## Index 425-001 Supplementary Details For Drainage Structures

SUPPLEMENTARY DETAILS  
FOR DRAINAGE STRUCTURES

INDEX  
425-001

INDEX 425-001	SHEET 8 of 8
------------------	-----------------

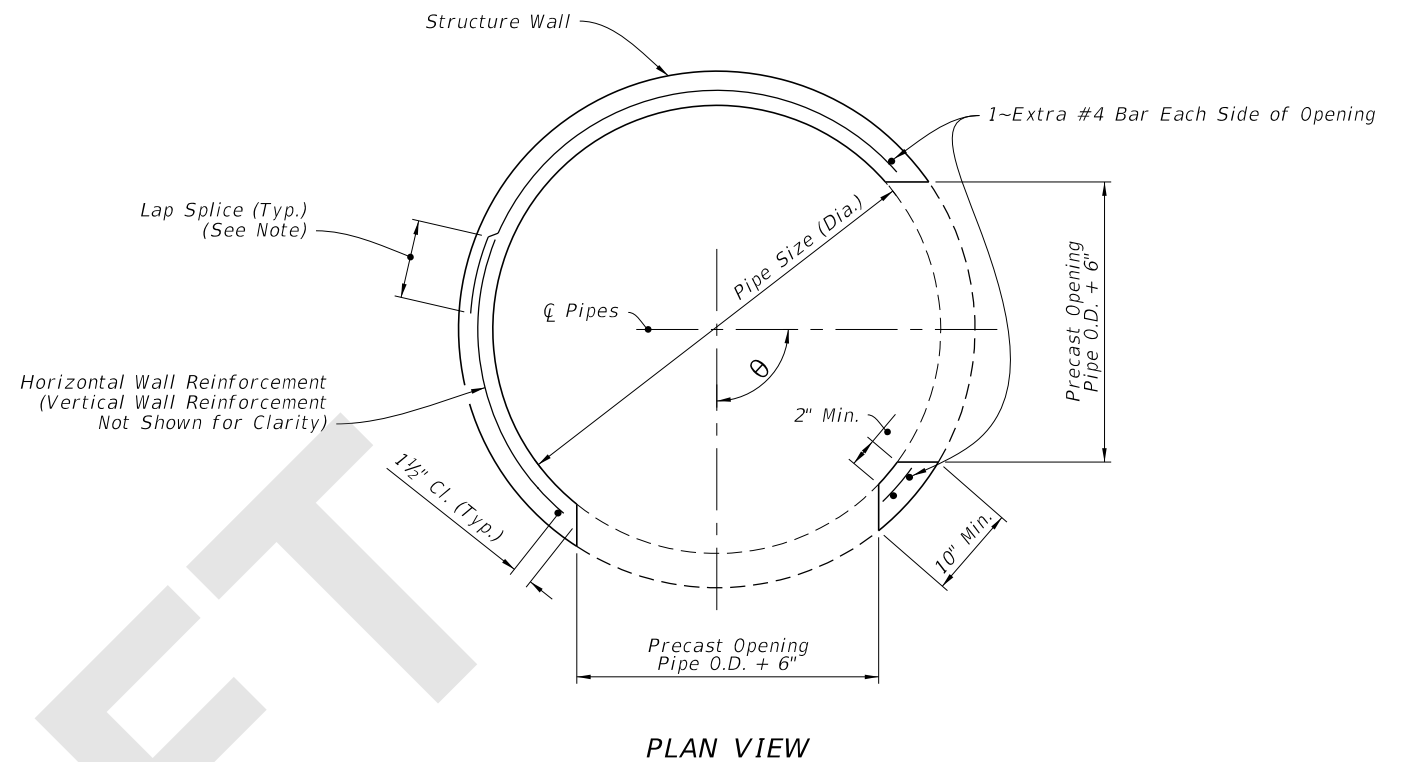
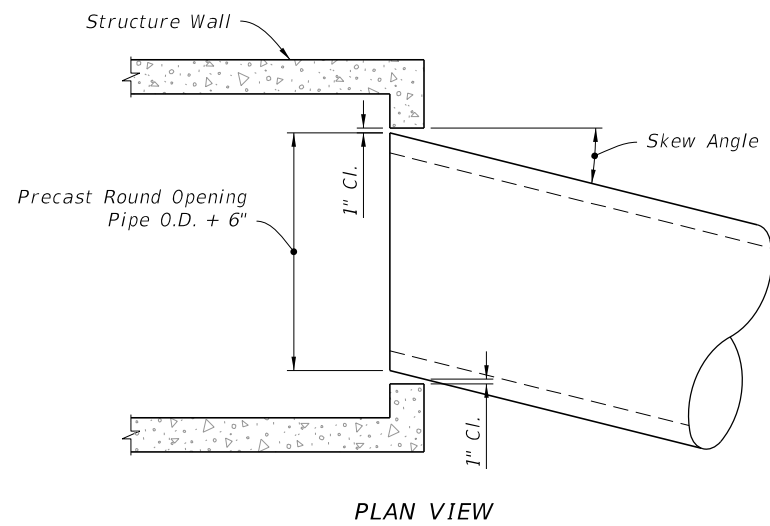
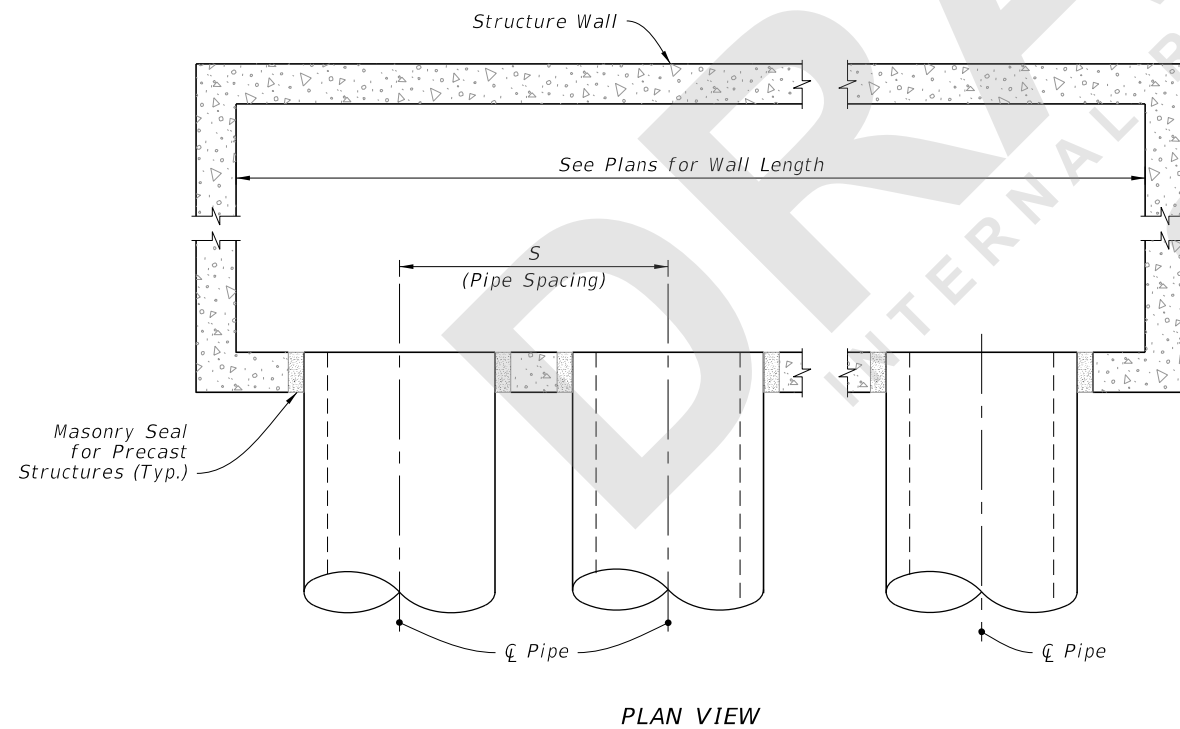
**COMMENT:** A lot of information is missing on sheet 8, which is the revision of sheet 3 of 5 of the old plan. The information RED lined as Table 6-4.2 in the Drainage Design Guide, which is current Table 3 and Table 4 "minimum structure sizes for single and multiple pipe connections per side for rectangular structures", does not exist in the Drainage Design Guide. I would suggest adding a NOTE on sheet 8 under Multiple Pipe Connections for Rectangular Structures, referencing the "Drainage Design Guide" for structure sizes for pipe connections.

**COMMENT:** Why was the table for "Minimum wall length (L) for number of parallel pipes" removed? If removed, why is there still dimension line showing 'minimum wall length (L)' within the diagram for number of parallel pipes? (Sheet 8 of 8)

**RESPONSE:** The "Minimum Wall Length (L) for number of Parallel Pipes" information that was deleted from Table 4 will be added to the DDG and referenced in the SPI. We will also reference table 6.4-2 in the SPI.

**RESPONSE:** This information is meant for designers, so the table is being moved to the Drainage Design Guide. Design information should be placed in design manuals, not the Standard Plans. We agree that the "minimum wall length (L)" needs to be deleted.

**Change made to Index:** On sheet 8 of 8, removed the dimension (L) Wall Length and instead reference the Plans for wall length.
